TITLE:
**ANDERSON HEIGHTS - UNIT 4
GRADING & DRAINAGE PLAN**

DRAINAGE AND TRANSPORTATION INFORMATION SHEET

**Re: Anderson Heights Unit 4 Grading and Drainage Plan
Revised Engineers stamp date 4-1-15 (N08 / D006F)
With revisions dates 4-22-15 (sht 3) and 4-14-15 (sht 4)**

RE: **Anderson Height Unit 4 (File: N08D006F)**
Drainage Report, Engineer's Stamp Date 2-12-2015
Grading & Drainage Plan Engineer's Stamp Date 5-1-2015

CITY OF ALBUQUERQUE PUBLIC WORKS DEPARTMENT	
TITLE: ANDERSON HEIGHTS - UNIT 4 GRADING & DRAINAGE PLAN	
DESIGN REVIEW COMMITTEE	CITY ENGINEER APPROVAL
LAST DESIGN UPDATE	MO./DAY/YR.
CITY PROJECT NO.	ZONE MAP NO.
SHEET 3 OF 4

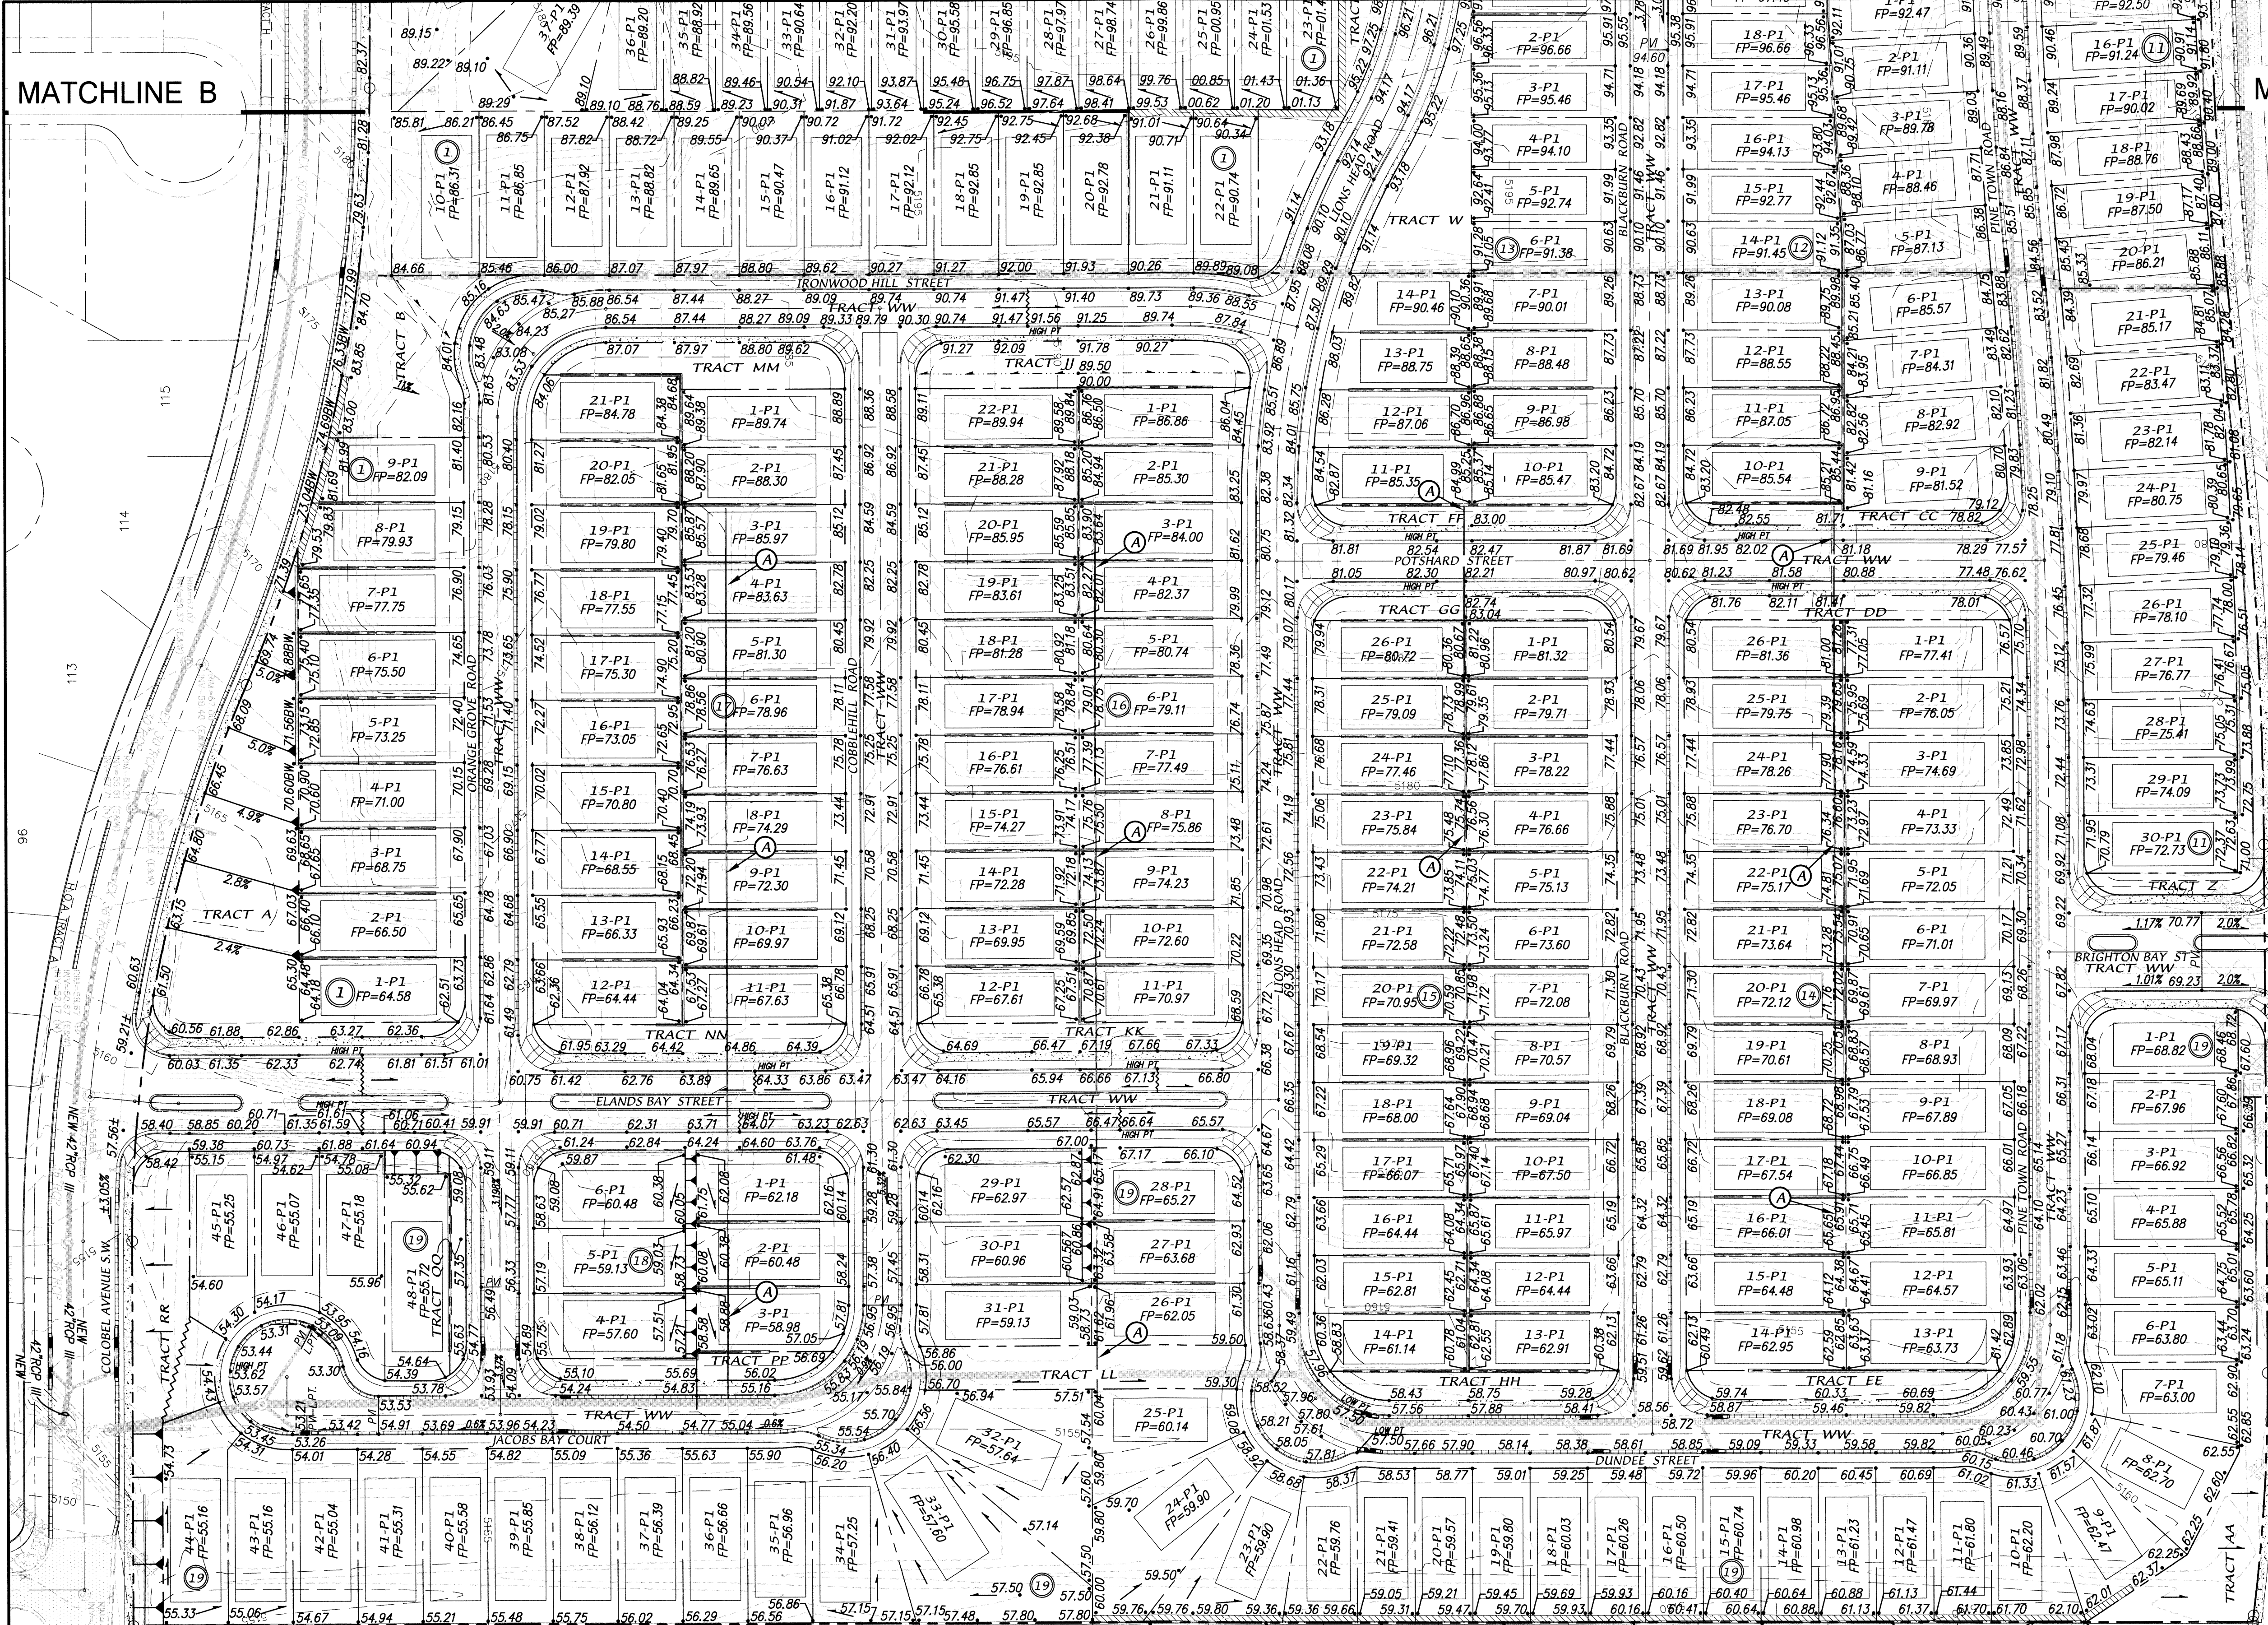
In response to comments received at DRB from Open Space and from conversations regarding the retaining walls along the east property boundary:

1. The Memorial Park was revised to add additional detail to the plan. The concept is unchanged just more detail.
2. The grades along the east property line were revisited. I have lowered the grades in Jacob Bay Court as much as possible while still maintaining minimum required cover over the storm drain. I have graded the backyards so that the grades are equal to or below the TWRW (top of west retaining wall).
3. The grades in Dundee Street remain unchanged. There is already minimum cover over the storm drain in this street. Consequently, the back yard grades, along Dundee Street, are higher than the TWRW. I have indicated proposed retaining walls along this area as shown on the revised plan. The maximum additional retainage is 2.0 feet.

SHEET
4

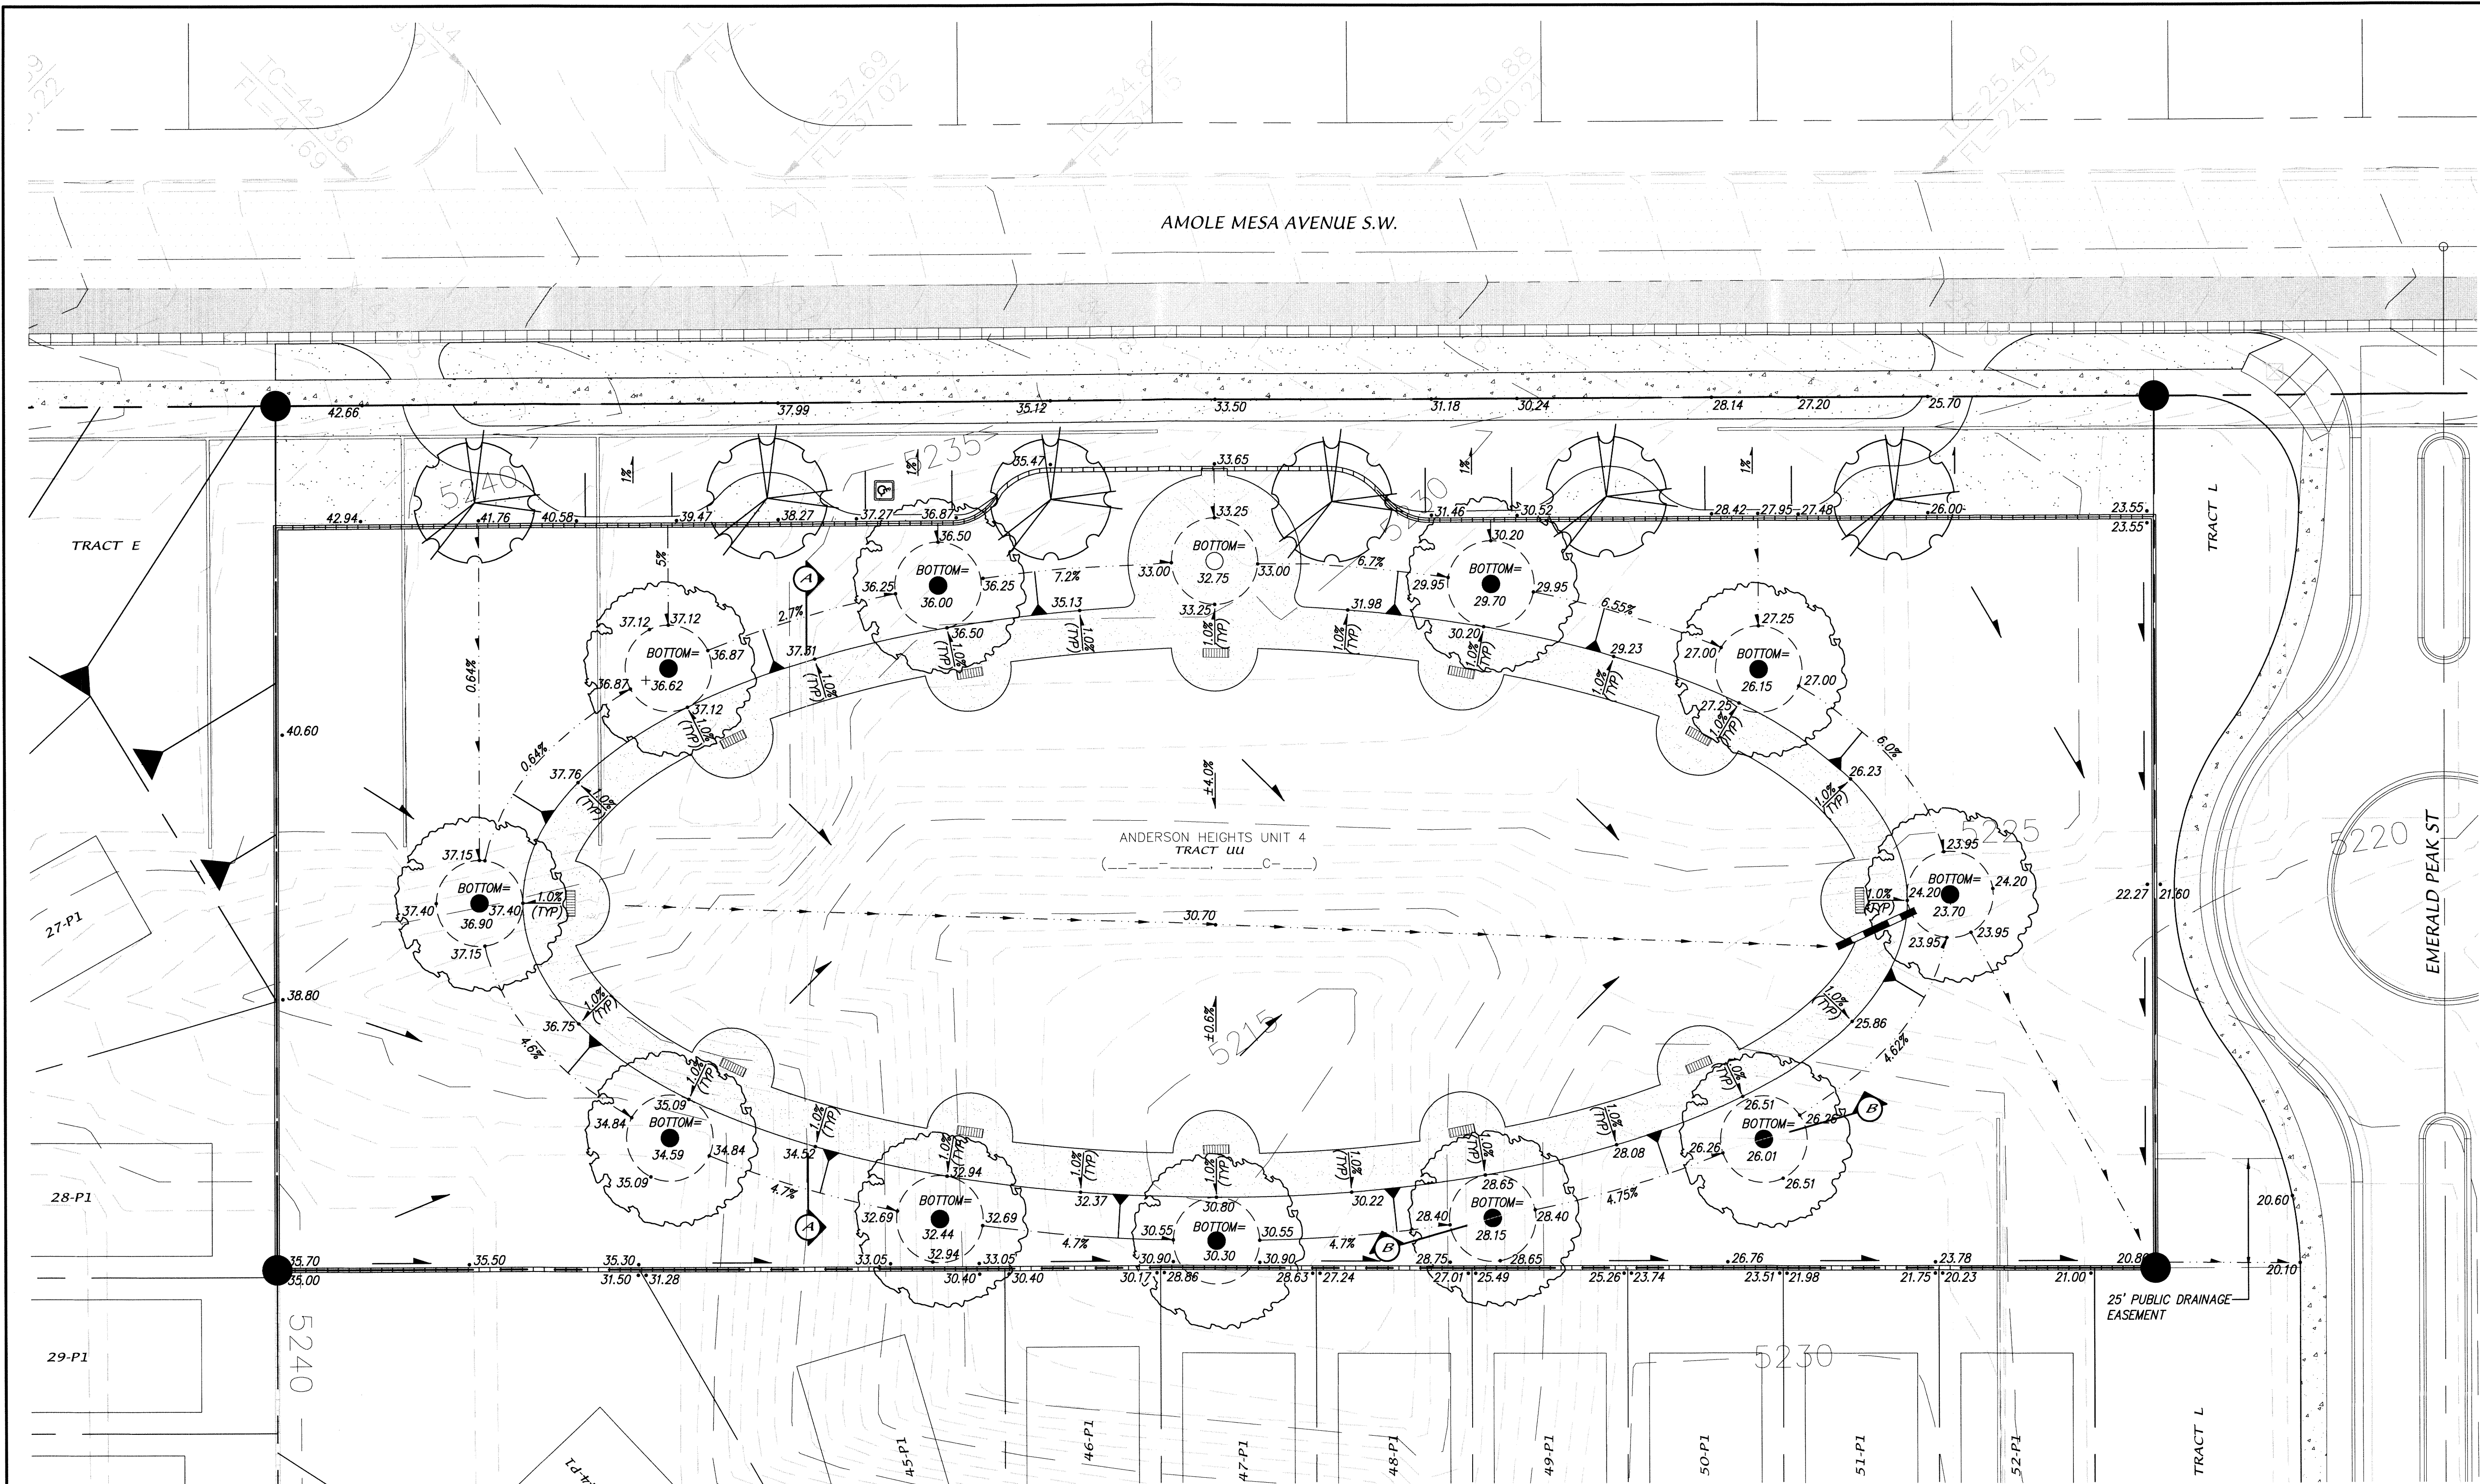
Based upon the information provided in your latest submittal received 5-1-15 (and prior submittals), the above referenced plan is approved for DRB action on the Preliminary Plat and Site Plan for Subdivision. Before Final Plat approval, show a drainage easement on Tract RR, and revise the Area Table on Tracts EE, HH, and PP.
